Invitation for Bid No. 2025-006

Union County Sheriff's Office Fuel Station

ADDENDUM No. 2

SHERIFF'S OFFICE FUEL STATION
MONROE, NC
Consultant Project No: 2241794

ELECTRICAL SITE PLAN

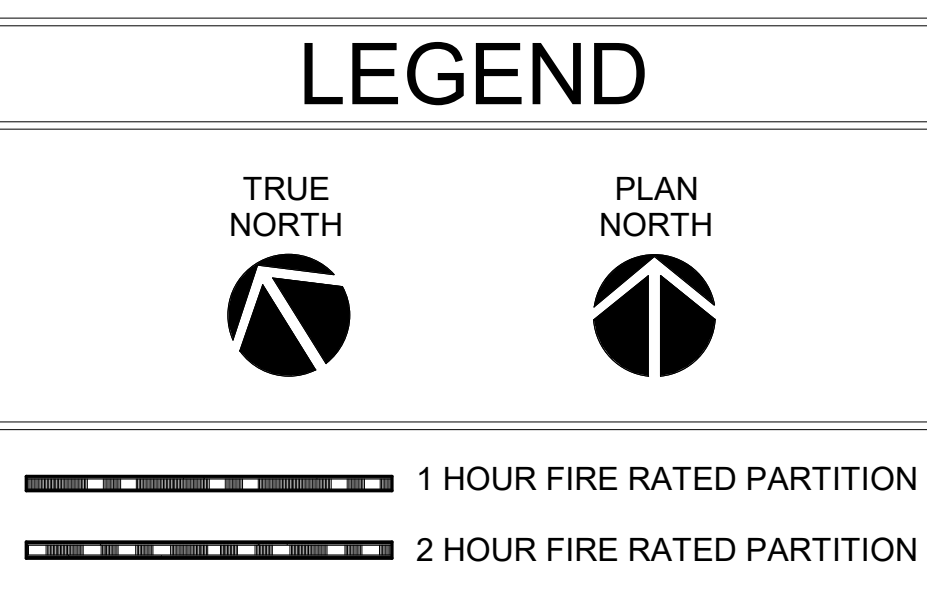
- a. If not, please provide updated drawing for concrete and privacy wall for estimating
7. Please send drawing of anticipated interior conduit path with anticipated linear footage as discussed at prebid.

12. Per review of the above plan sheet (G001). Per note Project Scope shown on the plan sheet noted above. Last item on scope list states to provide security camera for area surveillance. No specifications have been provided for this security camera. Will this be provided direct by Owner? Will we only need to provide conduit with pull string for final installation to be complete by Owner? Provide security plan sheet showing where conduits from new camera will need to be installed from starting point to final connection point.

7. Interior conduit routing plan attached for reference.
8. Extension of the bid date issued as Addendum 1,
9. Yes, lifts are acceptable to use.
10. Fuel resistant caulking added to detail on sheet A101.

12. Cameras provided by owner. Conduit and cabling provided by contractor from main electrical room to fiber cable box on fuel station enclosure. Contractor to provide conduit with pull string from cable box to fuel dispenser and camera locations. Interior conduit routing plan attached for reference.

A101

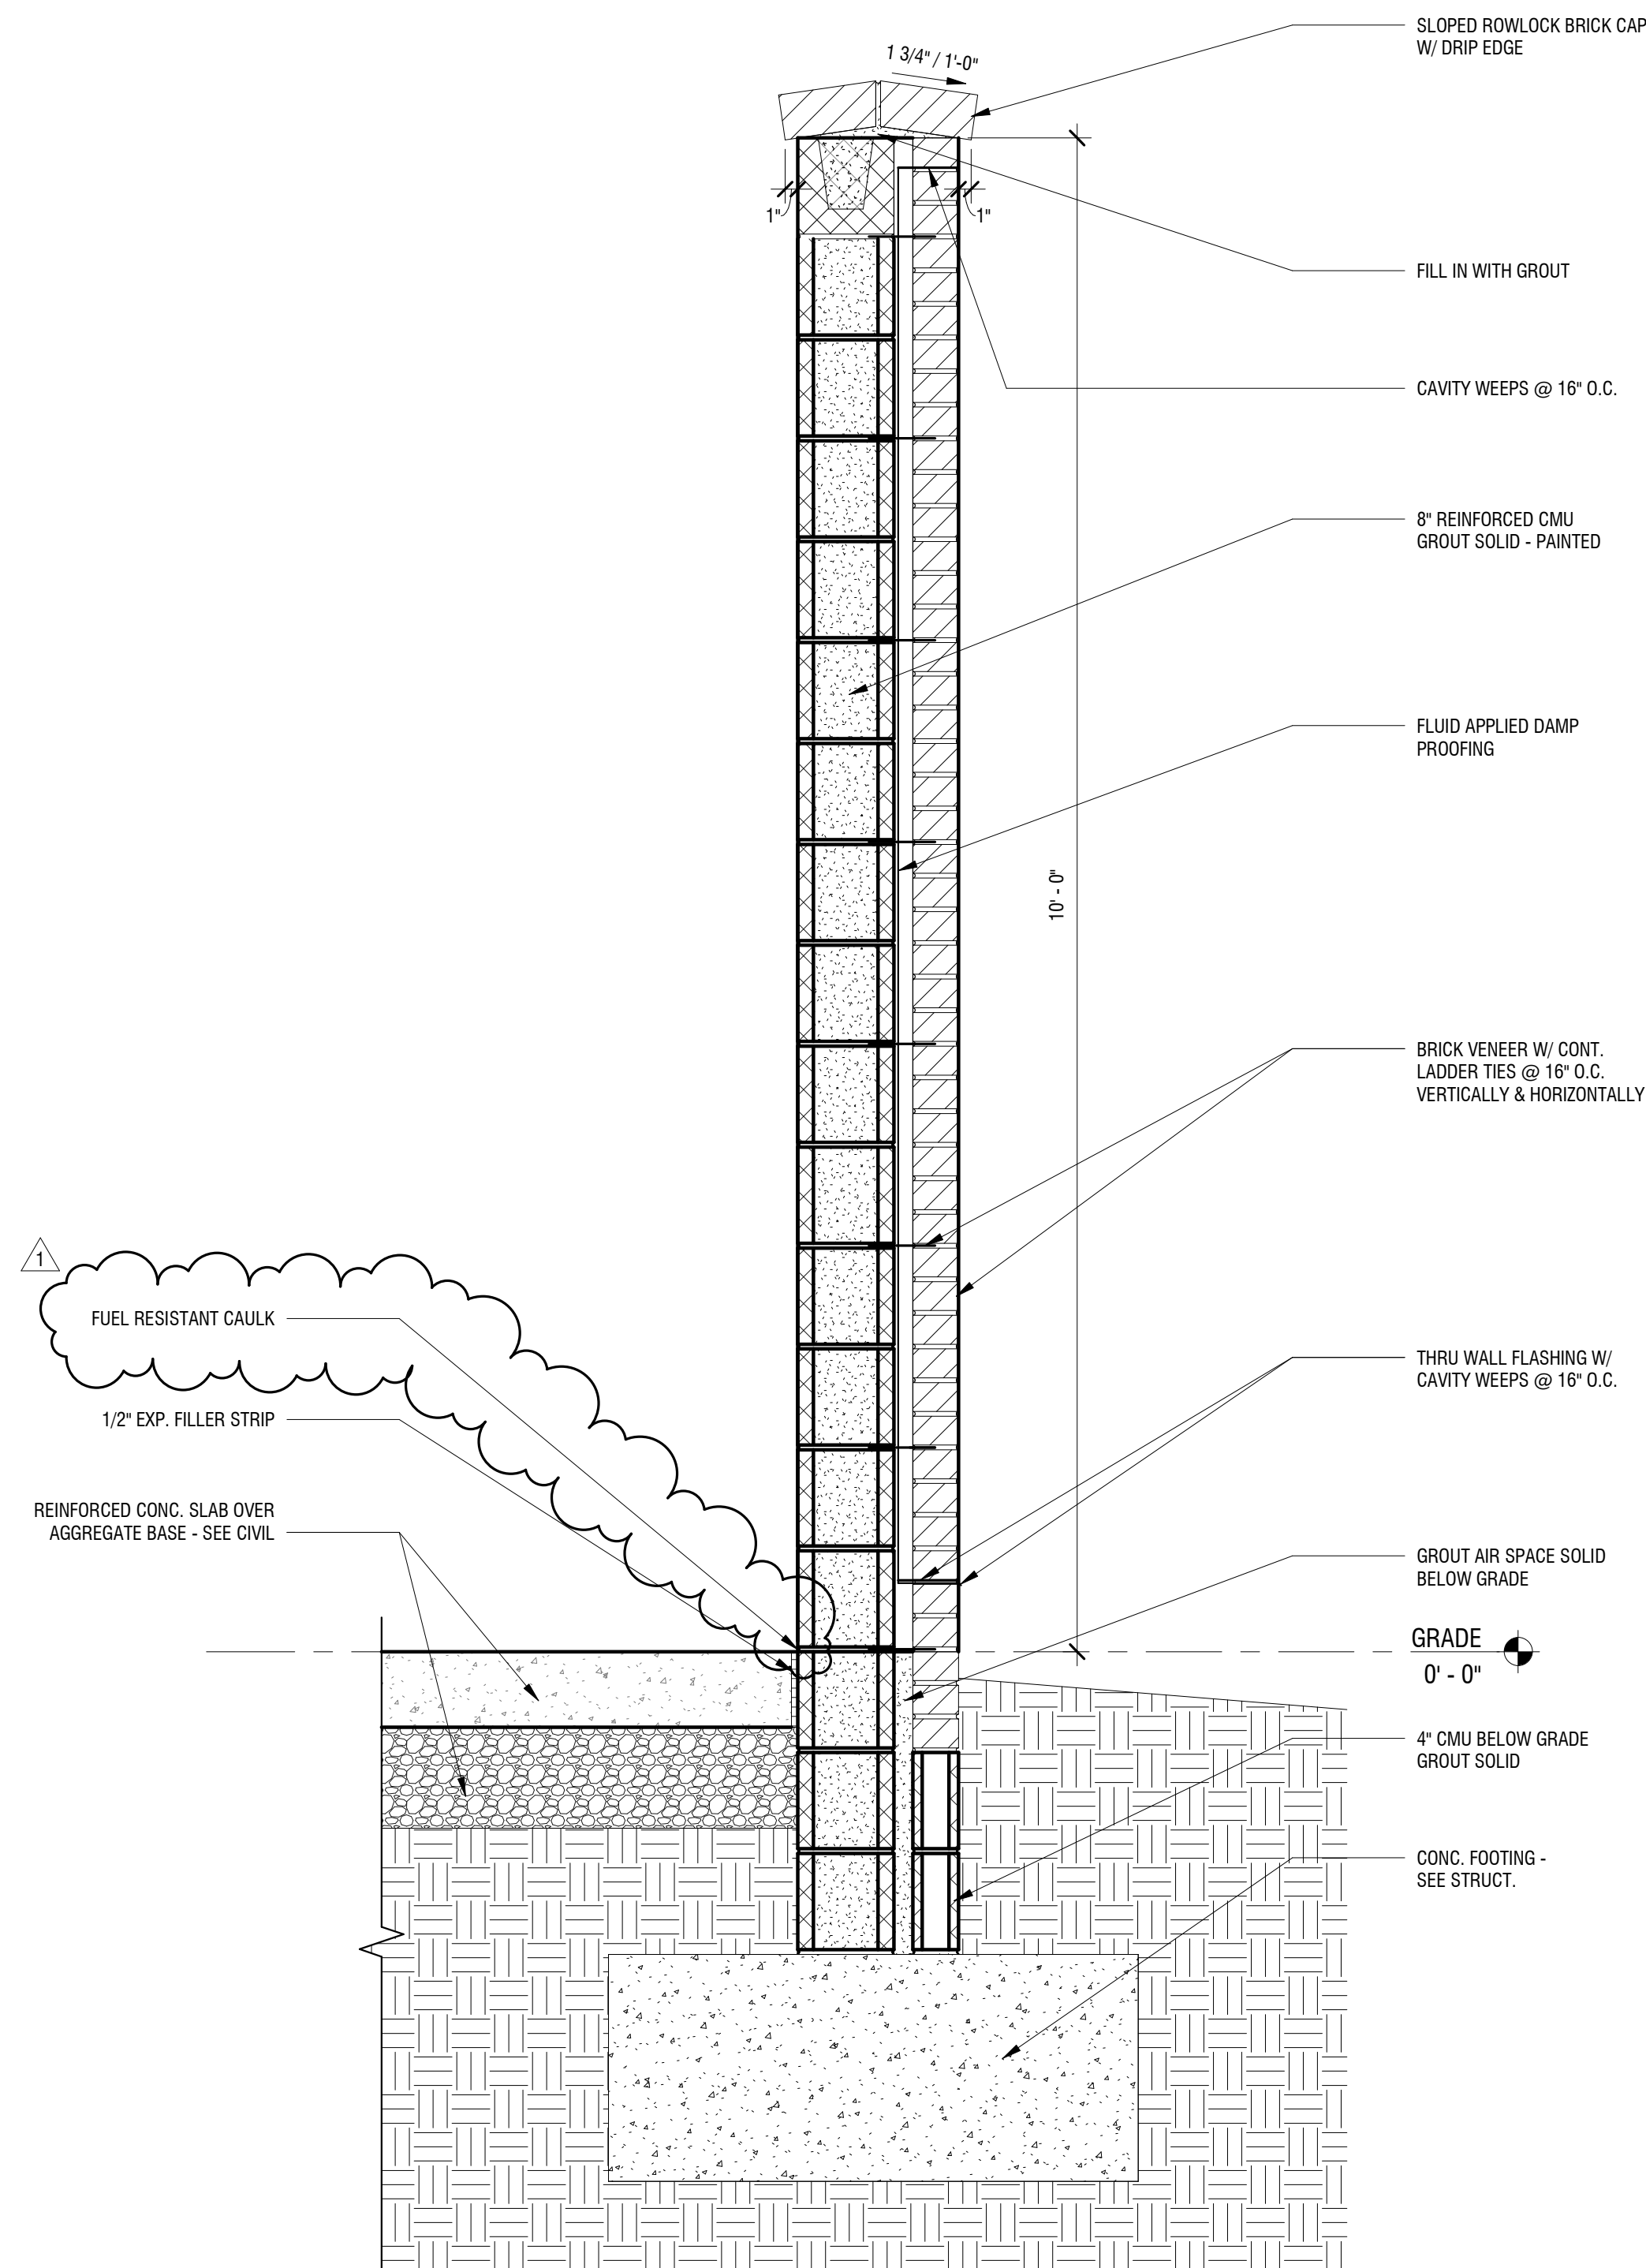
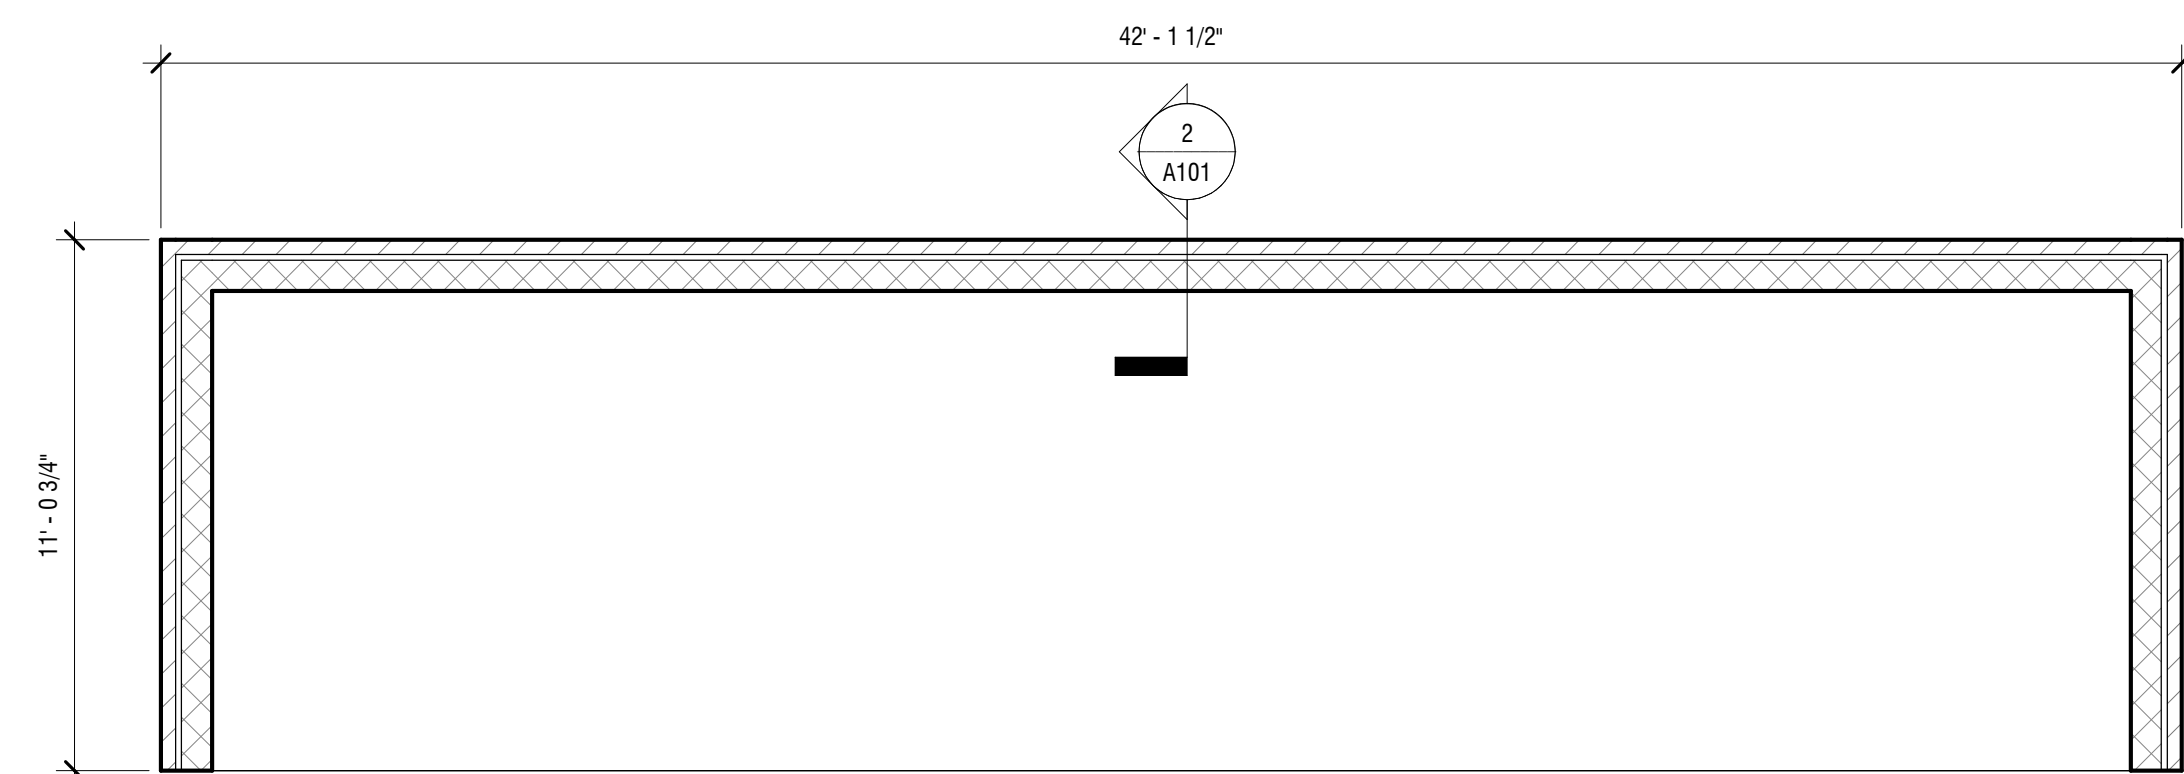
10. Per review of the above plan sheet. No Fuel resistant caulking as been shown to be installed around top of expansion joint materials around the bottom of the new concrete slab where it butts up to new CMU walls. Review this issue and confirm if this will be required.

11. Per review of the above plan sheet. "8" Reinforced CMU Grout Solid-Painted" No paint specifications have been provided on plans or specifications for these CMU walls. Provide paint specifications for the paint for these CMU walls so it can be priced correctly.

13. Per review of the above plan sheet (A101). Please provide specifications on the existing brick that was used for the new Sheriff's office so correct masonry materials can be priced to match existing brick materials.

11. Provide 1 coat of primer, Sherwin Williams Pro Industrial Block Filler (Sales # 650515430), and two coats of Sherwin Williams, Loxon Self Cleaning Satin – Network Grey paint

13. Brick: Palmetto Brick - Chocolate Wirecut; Mortar: Holcim Type N
